CITY OF SAN ANTONIO

Re: Peerman / De La Vega

MDP/POADP # 720

Re: Peerman/De La Vega, Level 3 TIA

**PEERMAN
P.O.A.D.P.**

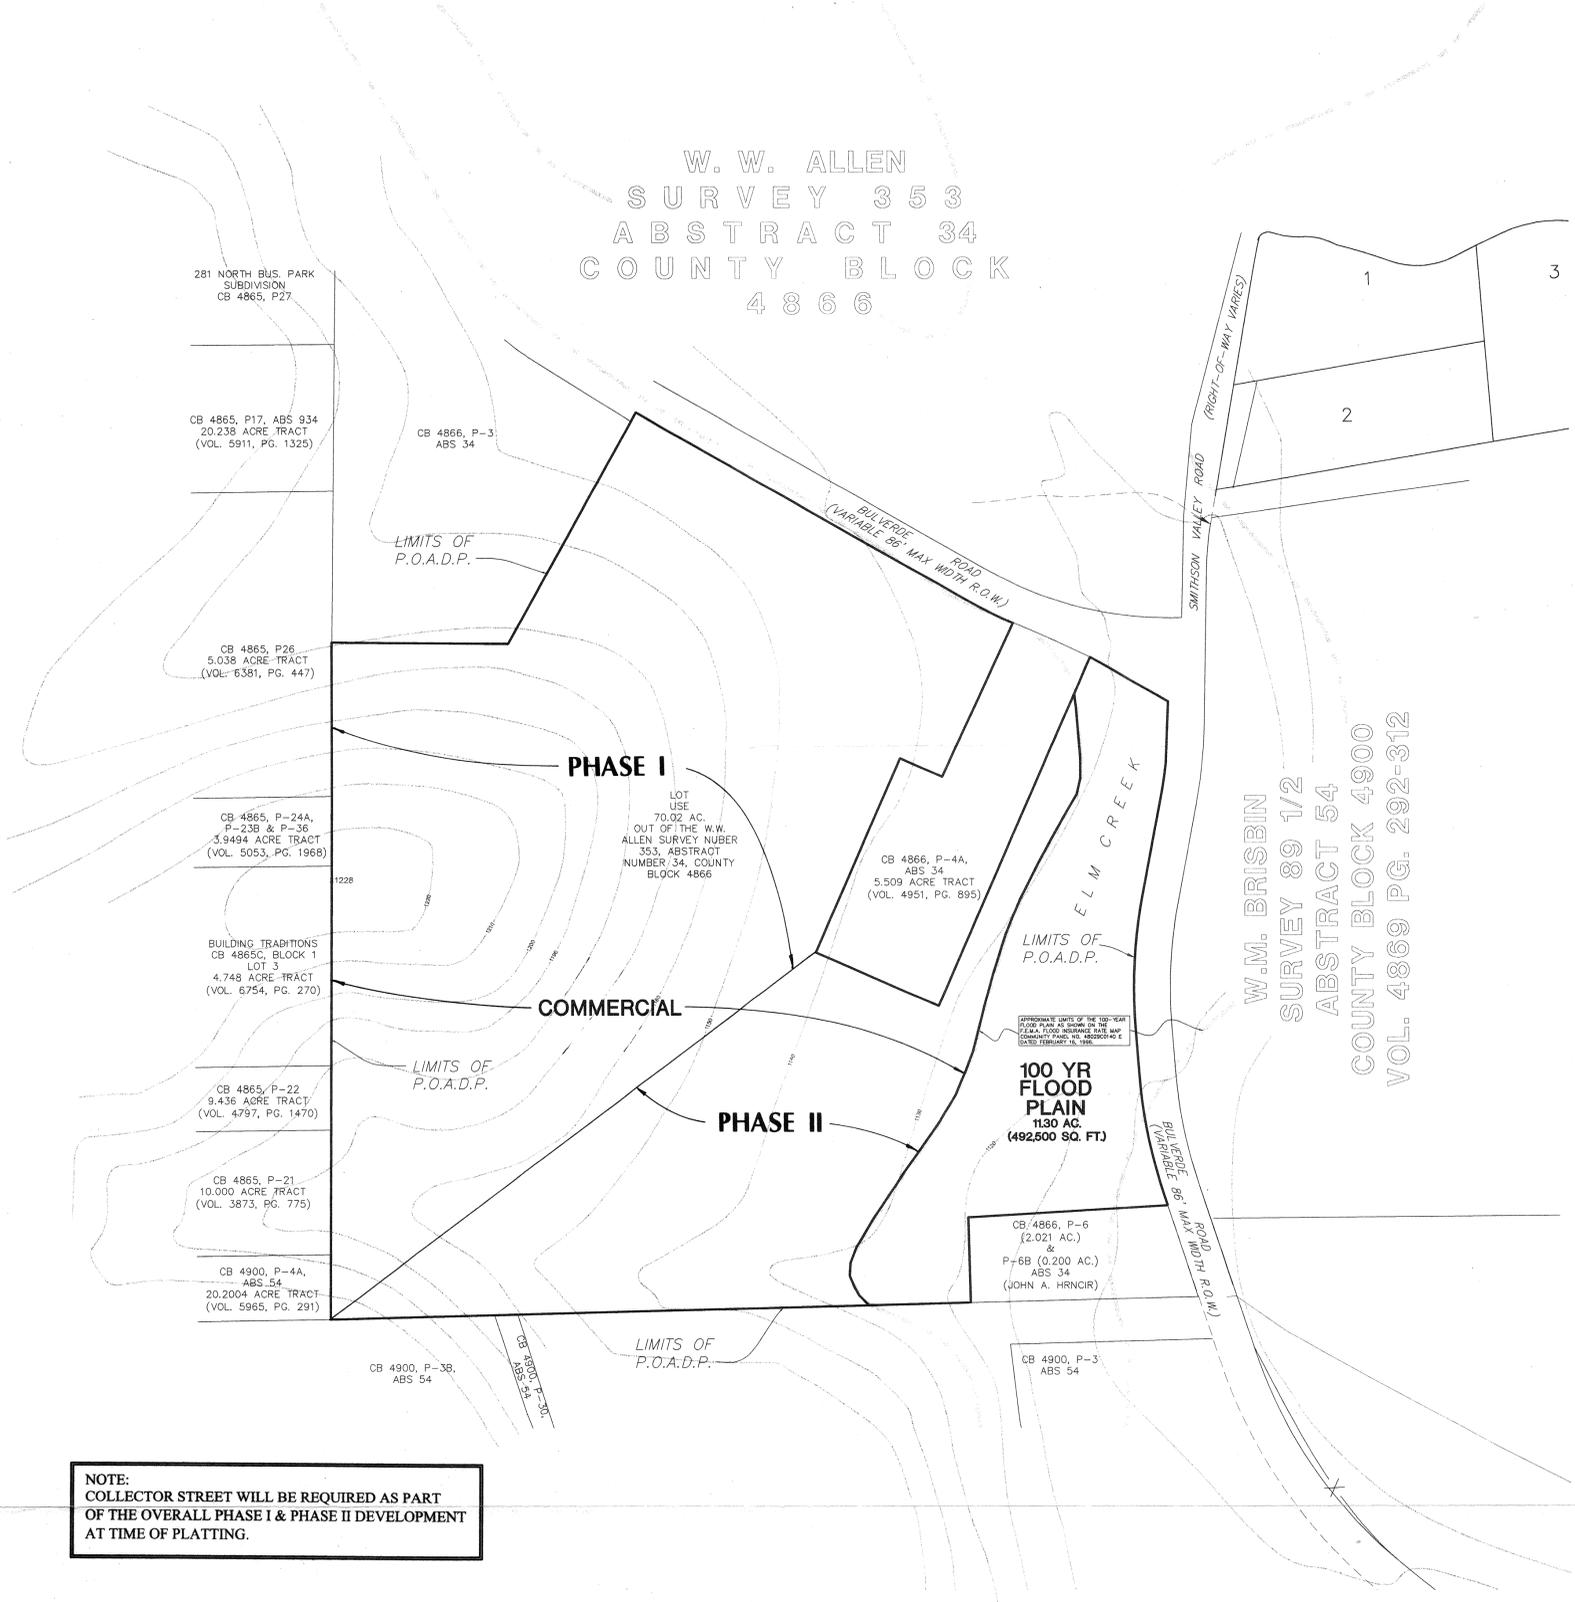
- In consideration of public safety and convenience, excessive grades by reason of topography should be avoided in street layouts and arrangements.
- Any access and R.O.W. issues along state facilities will need to be resolved with the Texas Department of Transportation (TXDOT). For information about these requirements you can contact TXDOT at 615-5814.

- a.) The proposed developments Peerman and De La Vega are located near each other and will require off-site improvements in conjunction with the on-site construction. Widening of Bulverde Road to a Primary Arterial type B (86 feet ROW) adjacent to the proposed project limits.

- b.) The Developer shall provide 43 feet of ROW from the centerline of Bulverde Road adjacent to these projects. This will require a property dedication by the developer.

- c.) Installation of a traffic signals at the intersection of Bulverde Road and Smithson Valley.
 - d.) Construction of a signalized intersection at the proposed Peerman Driveway 2 on Bulverde Road a min. ¼ mile away from the Bulverde Road / Smithson Valley intersection and a min. of ¼ mile away from the De La Vega subdivision road traffic signal.

- e.) Construct a signalized intersection at the intersection of De La Vega subdivision road and Bulverde Road a min. of ¼ mile away from the Peerman Driveway 2 and a min. ¼ mile away from the Bulverde interchange at US Highway 281.
- This development will need to comply with tree preservation ordinance #85262. For information about these requirements you can contact Building Inspections at 207-7102.
 - It will be expected that you will plat all of the property depicted in your Master Development Plan (M.D.P.) (formerly POADP), to include floodplains, drainage areas and open space.
 - I would encourage you to work closely with the school district, so that they can plan accordingly.
